UNITED STATES PATENT AND TRADEMARK OFFICE

APPLICATION NO.	FILING DATE	FIRST NAMED INVENTOR	ATTORNEY DOCKET NO.	CONFIRMATION NO.
09/954,994	09/18/2001	Sven K. Esche	SIT-0106	2909
26259	7590	06/20/2006	EXAMINER	
LICATA & TYRRELL P.C. 66 E. MAIN STREET MARLTON, NJ 08053			BURCH, MELODY M	
			ART UNIT	PAPER NUMBER
			3683

Office Action Summary

DETAILED ACTION

Annotated figure showing the dotted longitudinal line

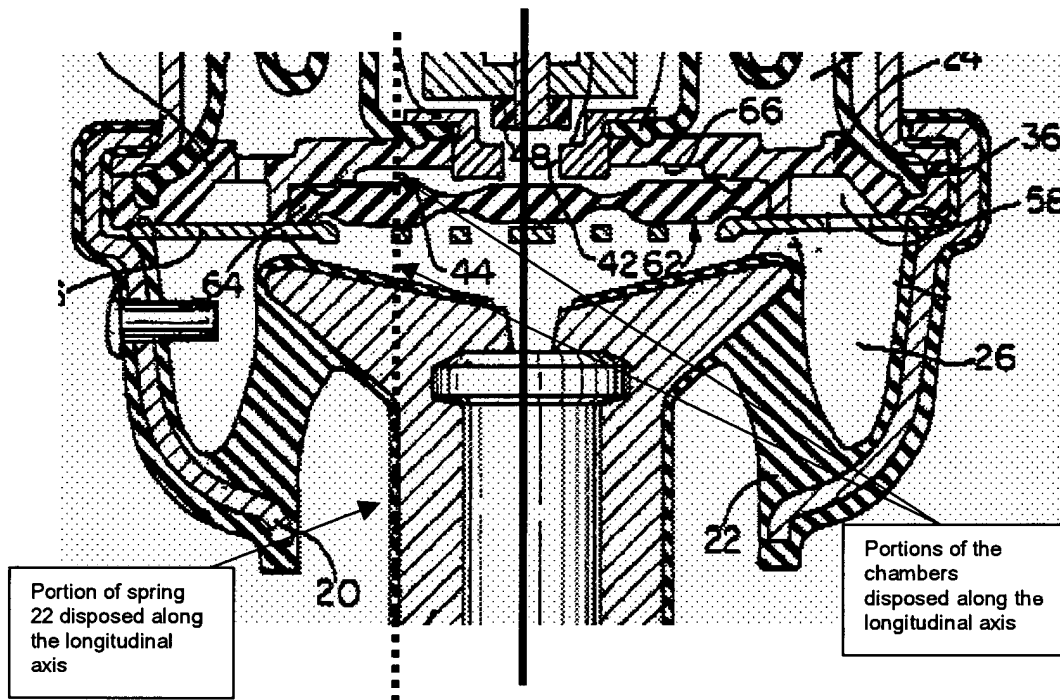
Re: claim 1. Shores et al. show in figure 1 a device for adaptive vibration attenuation comprising a passive isolator 22 with a force-deflection characteristic and an operating point wherein the passive isolator comprises a pneumatic actuator 44, 62, and the vacuum actuated valves discussed in col. 2 lines 37-38 which varies the operating point of the isolator along the force-deflection characteristic wherein the pneumatic actuator comprises at least one upper pressure chamber 44, a spring 22 (in light of Applicant's remarks on 6/23/03 that the passive isolator is the non-linear spring), and one lower pressure chamber 26 independent of the upper pressure chamber wherein air pressure in the at least one upper pressure chamber can be externally controlled as disclosed in col. 2 lines 31-39 and wherein the natural frequency of the system is regulated by applying pressure to the upper pressure chamber or the lower pressure chamber, particularly the upper pressure chamber. Examiner notes that "upper" and "lower" are relative terms and that for examining purposes the upper portions of the

mount in figure 1 are shown in the area of element 14 and the lower portions of the mount are shown in the area of element 16.

With regards to claim 1, Applicant argues that Shores, as modified, fails to disclose the limitation wherein "the pneumatic actuator has disposed along the longitudinal axis a non-linear spring, at least one upper pressure chamber and one lower pressure chamber...." Examiner notes that the dotted line in the annotated figure shown on pg. 6 of this action illustrates the limitation of the actuator having disposed

along the longitudinal axis or dotted line, a spring 22 and at least one upper and lower pressure chambers 44 and 26, respectively.
